Date: May 7, 2026
To: All Prospective Bidders
From: Candida Poinsette
Assoc. Director of Procurement Services
Re: Addendum Number 2
IFB # C1747 – Façade Repairs – Kaufman Hall

Re: Façade Repairs
Kaufman Hall
Fashion Institute of Technology
406 West 31st Street
New York NY 10001

Questions IFB # C1747 – Kaufman Façade Repairs

3 CORNER COLUMN REPAIR
A-206 SCALE: 3"=1'-0"

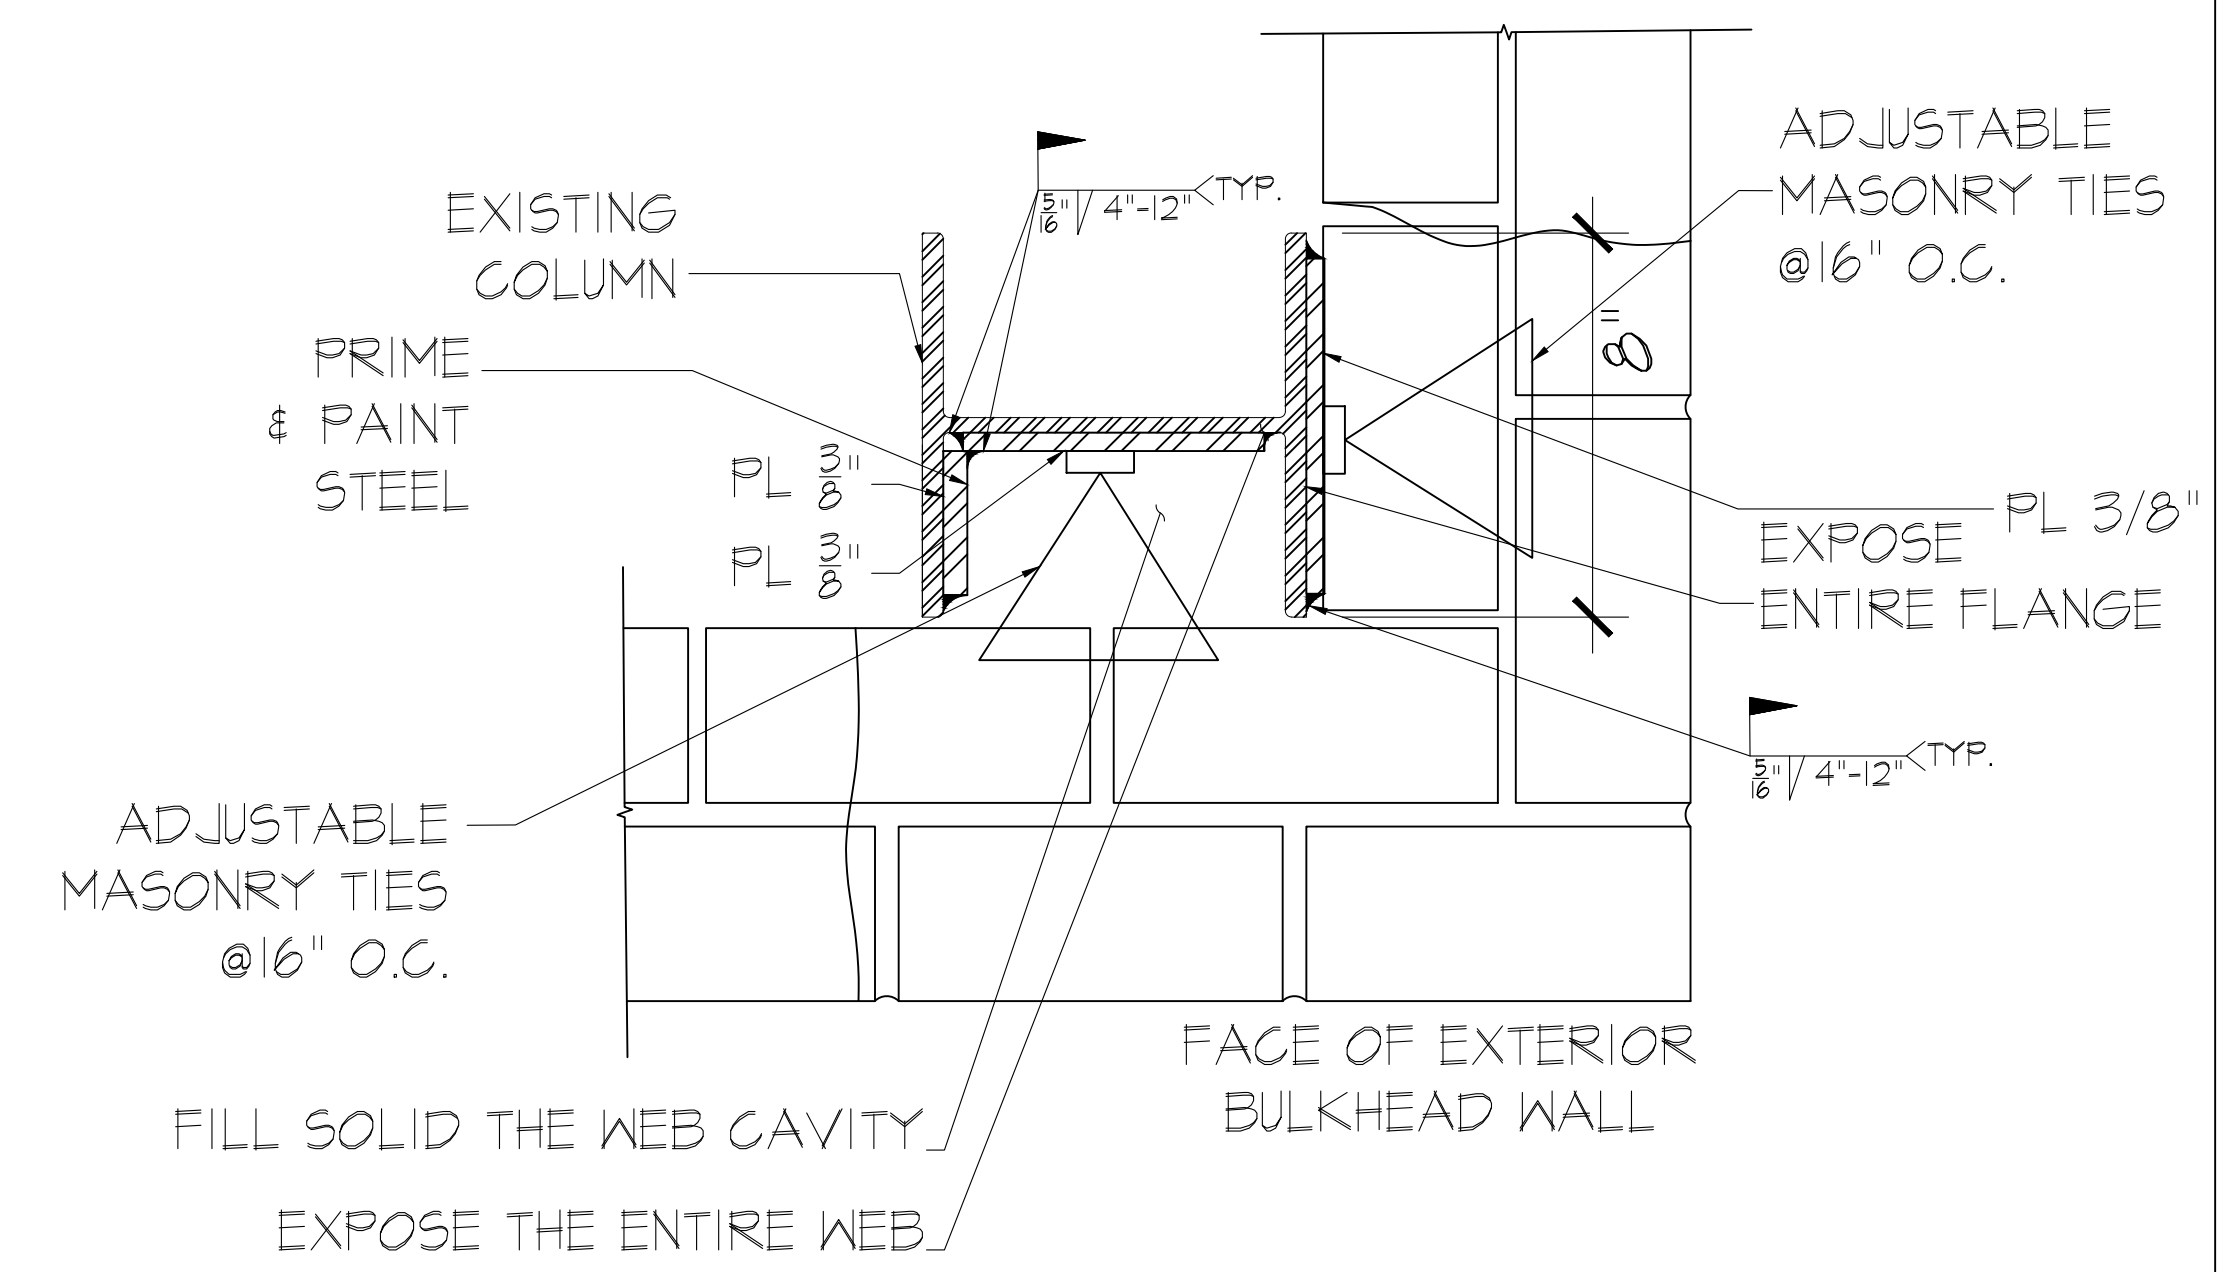
RFI #20 Response. Section 4.2 – Corner Repairs: Is there a detail available for this repair? Are we replacing any backup brick? If so, how many courses? The description references Drawing A-301; however, these sheets were not included in our bid package.

RFI #28. Section 4.2: Is there a detail available for this repair? Are we replacing any backup material? If so, how many courses? The description references Drawing A-301; however, these sheets were not included.

RFI #20 Response. See revised drawing, Detail 3/A-206

RFI #28 Response. See revised drawing, Detail 3/A-206

4 SHELF ANGLE @ NW & NE CORNER - REPAIR DETAIL
A-206 SCALE: 3"=1'-0"

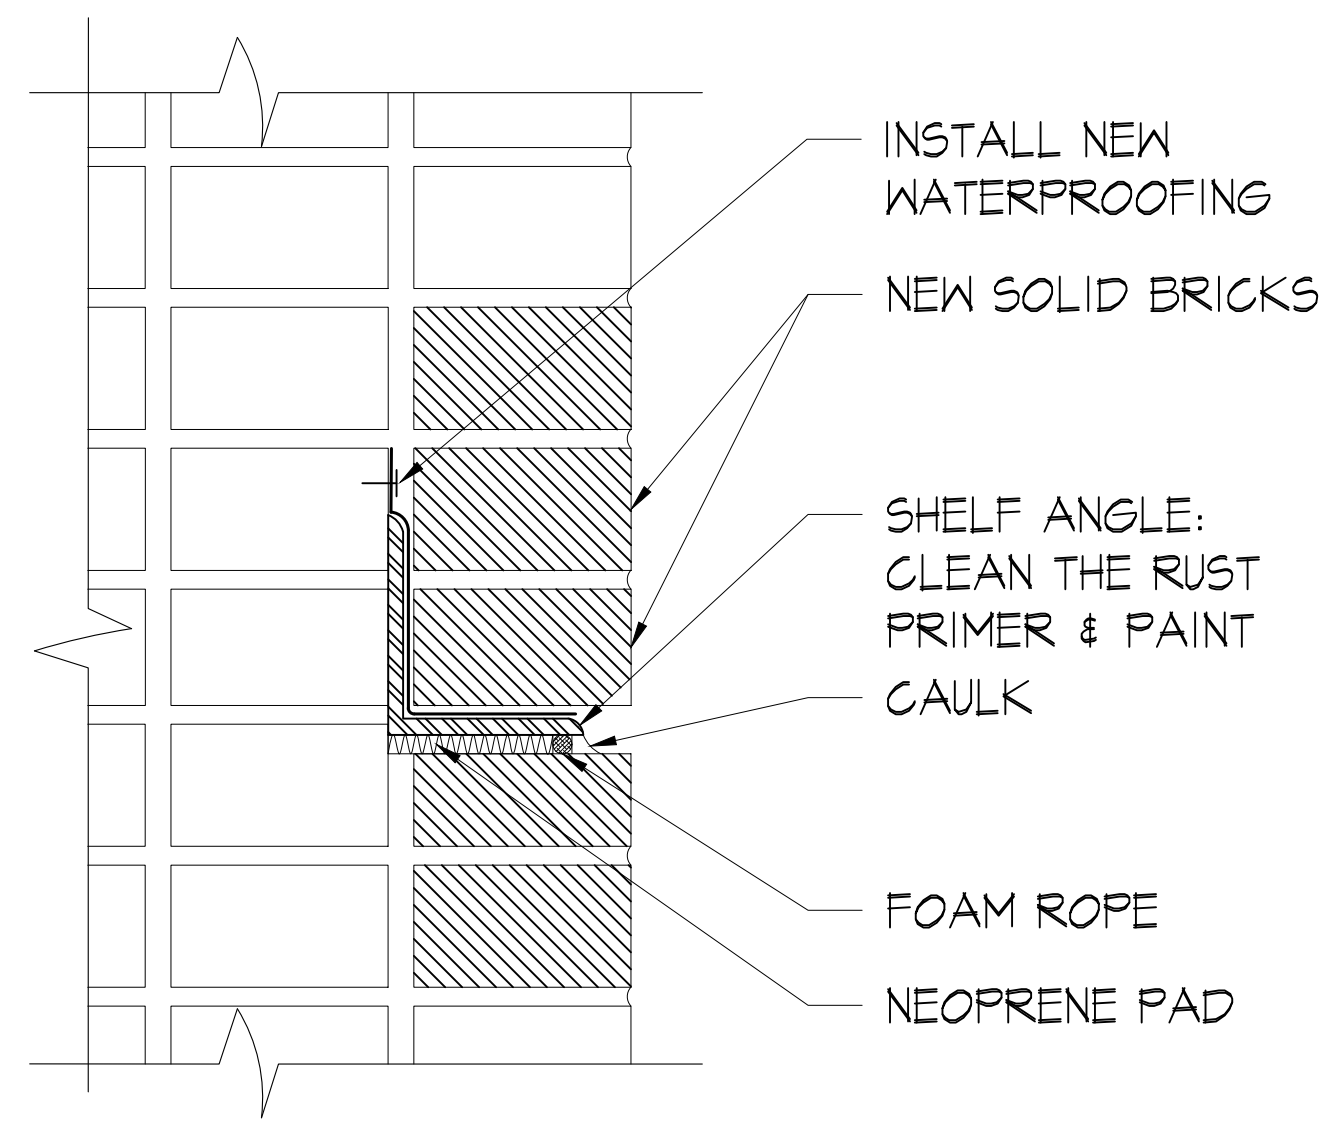
RFI #25. Section 6A – Shelf Angle Repair (Type A): Is there a detail available for this repair? Is this repair only including SPP of existing shelf angle and not replacement. Please confirm.

RFI #25 Response. See drawing, Detail 4/A-206
